## Design Change of Flexible Shaft Coupling, Disk Type, MHW-C/MHS-C

Product Name	Applicable Sizes	NBK Catalog 2017 Listed Page
Flexible Couplings Disk Type	MHW-C/MHS-C Series, All Sizes	p.93 to p.96

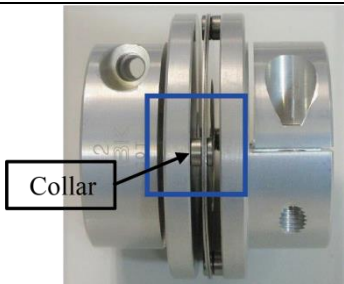
The color will be changed from silver to black for the purpose of identifying the parts.  
Product performance and pricing will not change due to these changes.

Before Change	After Change
Surface Treatment	No	Stainless Steel Black
Appearance (For MHS)	Collar Section Enlarged
